General Bid Bulletin No. 15
16 July 2021

**THE MALOLOS-CLARK RAILWAY PROJECT AND THE NORTH-SOUTH RAILWAY
PROJECT SOUTH LINE COMMUTER PACKAGE CP NS-01: PROCUREMENT OF
ELECTRICAL AND MECHANICAL SYSTEMS AND TRACK WORKS (IFB No: 21-040-3)**

PACKAGE CP NS-01: E&M SYSTEMS AND TRACK WORKS
General Bid Bulletin No. 15
Annex A

PACKAGE CP NS-01: E&M SYSTEMS AND TRACK WORKS
General Bid Bulletin No. 15
Annex B

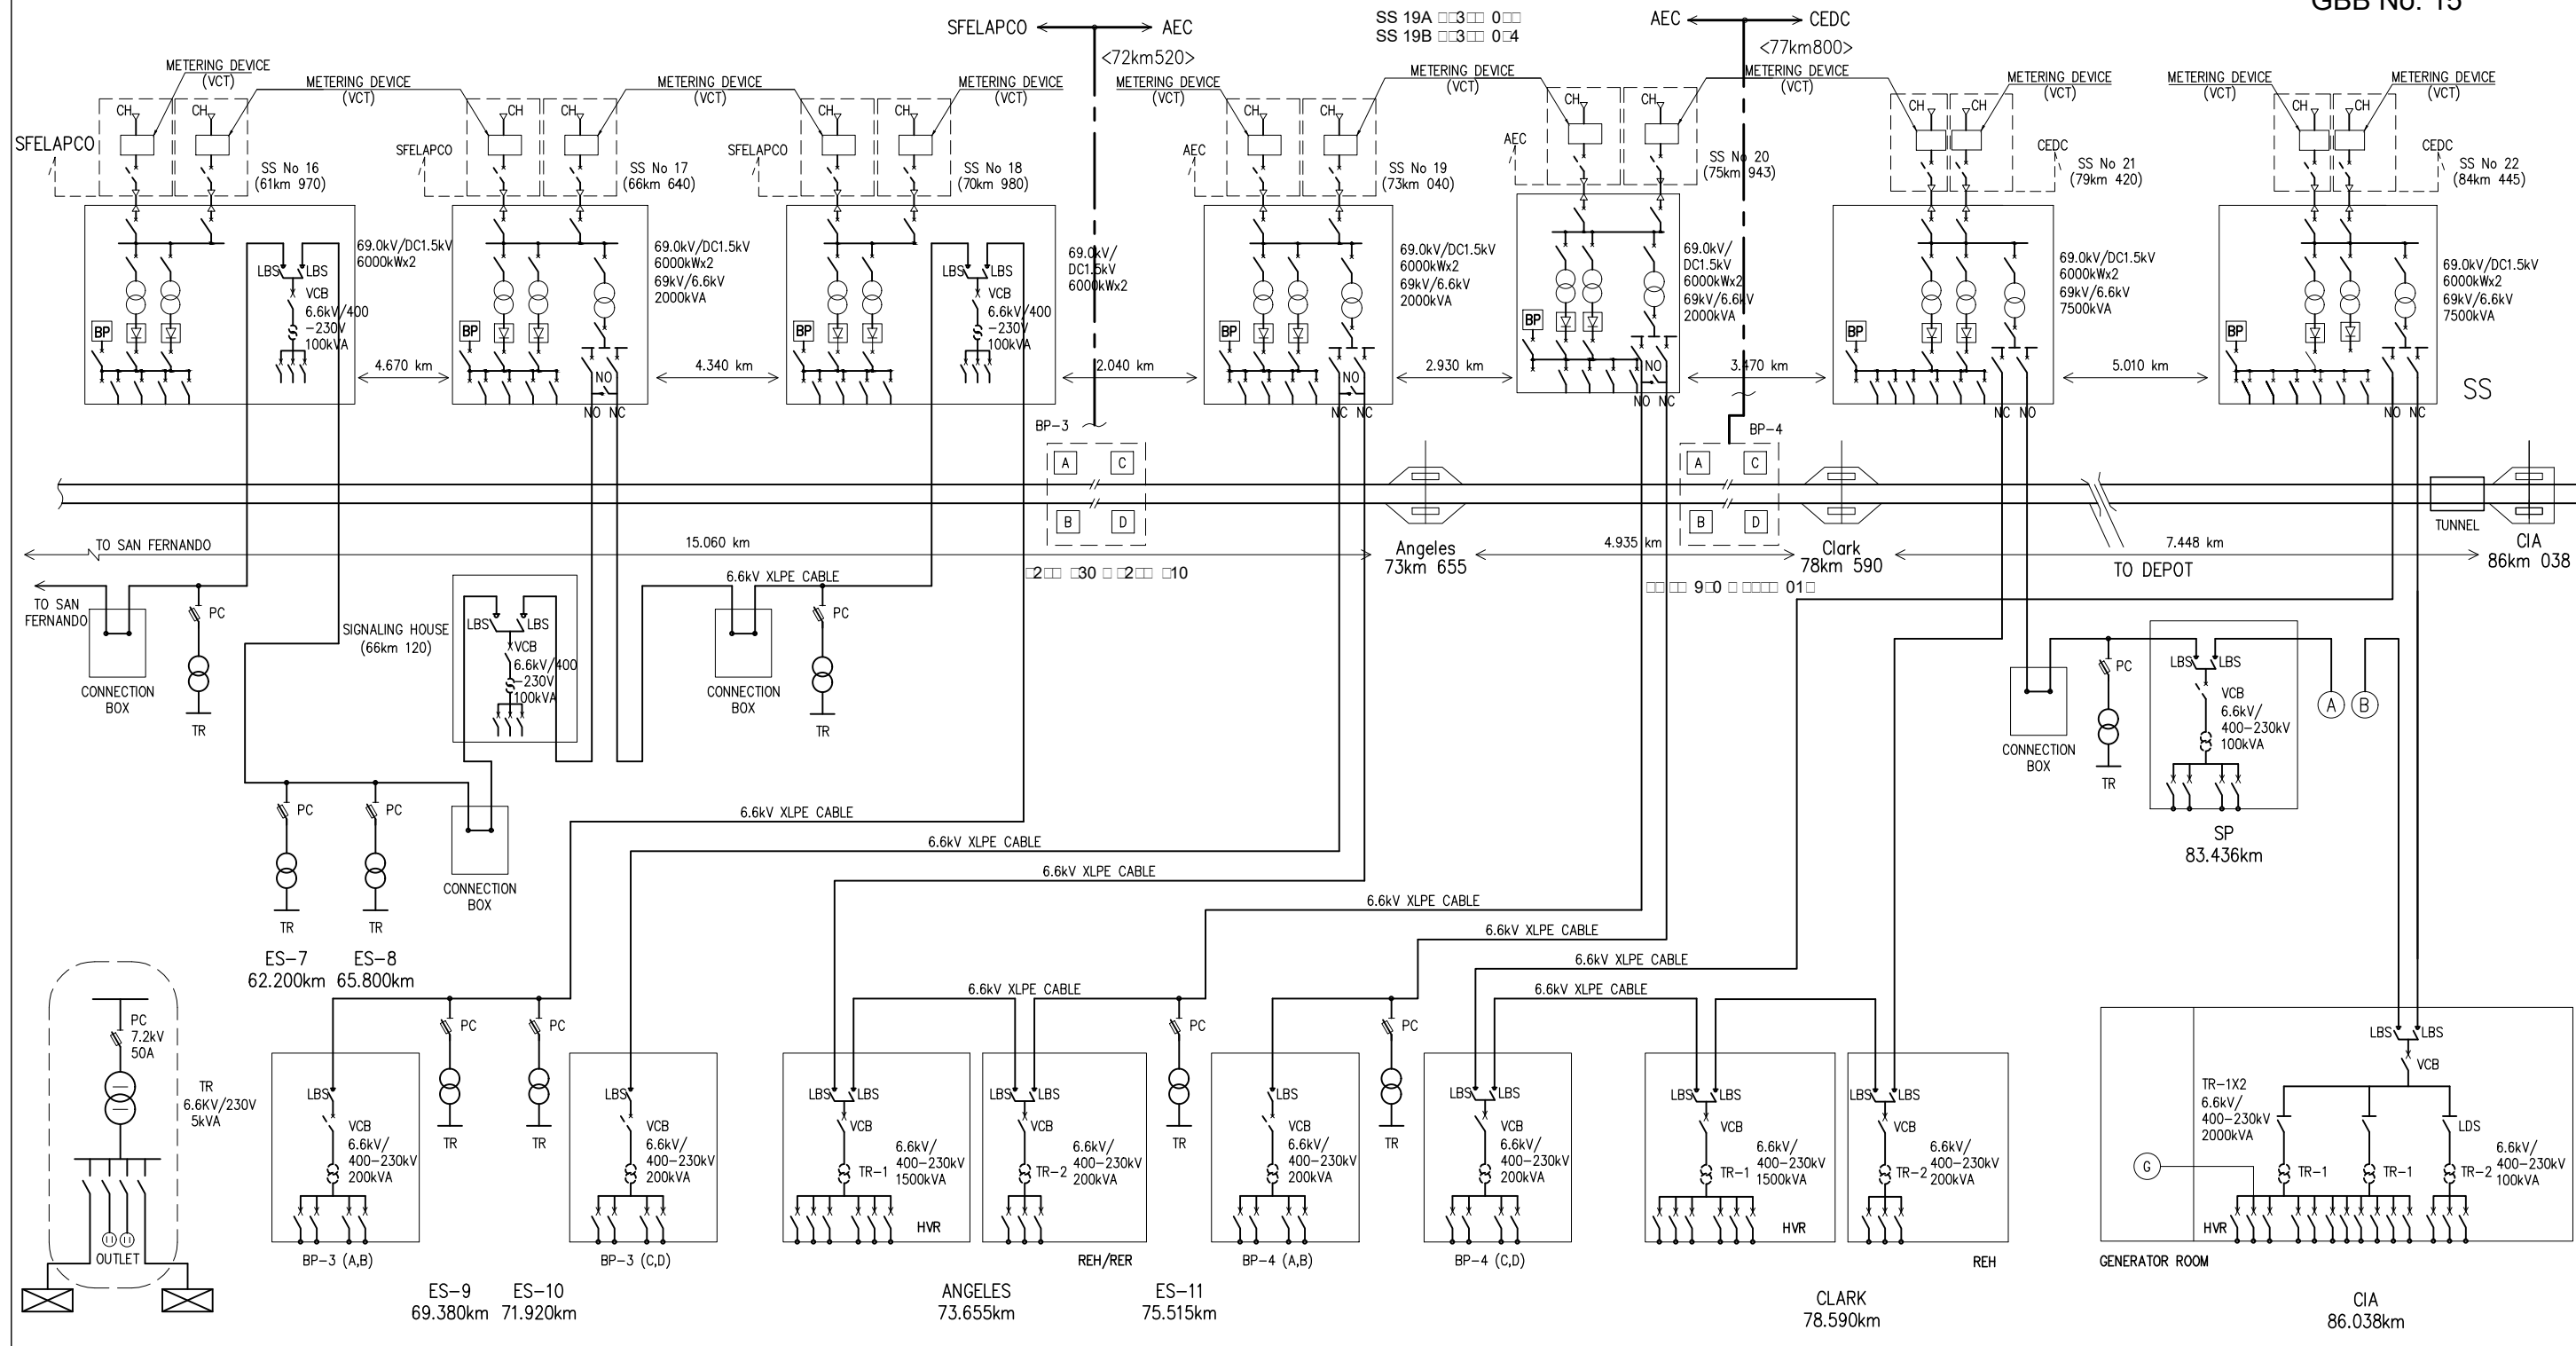
9	Part 2 Vol.3 E_M Version 11.0 FINAL Rev. A. ERD (a) page 194	Revised drawing Substation Connection (SS DEPOT)
10	Part 2 Vol.3 E_M Version 11.0 FINAL Rev. A. ERD (a) page 234	Revised drawing: 6.6kV Power Supply Schematic Diagram 1/2
11	Part 2 Vol.3 E_M Version 11.0 FINAL Rev. A. ERD (a) page 235	Revised drawing: 6.6kV Power Supply Schematic Diagram 2/2

VERSIONS	DATE	DESCRIPTION
00	02 MAR 2021	ISSUED FOR REFERENCE
01	24 JUN 2021	RESISTOR CHANGED TO BP □ SS NO.17 TO SS NO.22 CHAINAGE RE-USED
